Project	<b>IEEE 802.16 Broadband Wireless Access Working Group</b> < <a href="http://ieee802.org/16">http://ieee802.org/16</a> >	
Title	<b>Fix Figures 391 and 392</b>	
Date Submitted	<b>2009-11-6</b>	
Source(s)	Joey Chou Intel	E-mail: [ <a href="mailto:joey.chou@intel.com">joey.chou@intel.com</a> ]  * <a href="http://standards.ieee.org/faqs/affiliationFAQ.html">http://standards.ieee.org/faqs/affiliationFAQ.html</a> >
Re:	Letter Ballot #30a	
Abstract	Proposed text for Figures 391 and 392	
Purpose	Present text for review and acceptance in 16m task group.	
Notice	<i>This document does not represent the agreed views of the IEEE 802.16 Working Group or any of its subgroups.</i> It represents only the views of the participants listed in the "Source(s)" field above. It is offered as a basis for discussion. It is not binding on the contributor(s), who reserve(s) the right to add, amend or withdraw material contained herein.

# Fix Figures 391 and 392

Figure 391— Packing variable length MSDUs into a single MAC PDU

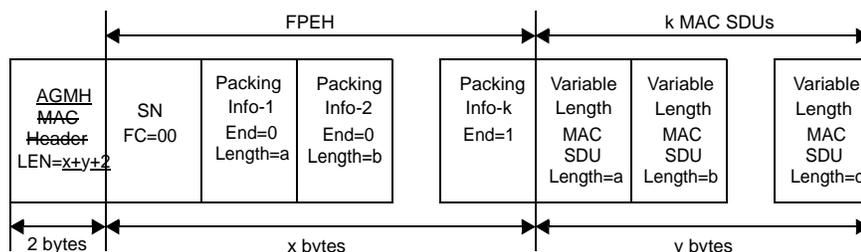
Quite a few places in Figures 391 and 392 are wrong. The contribution proposes changes to fix those places.
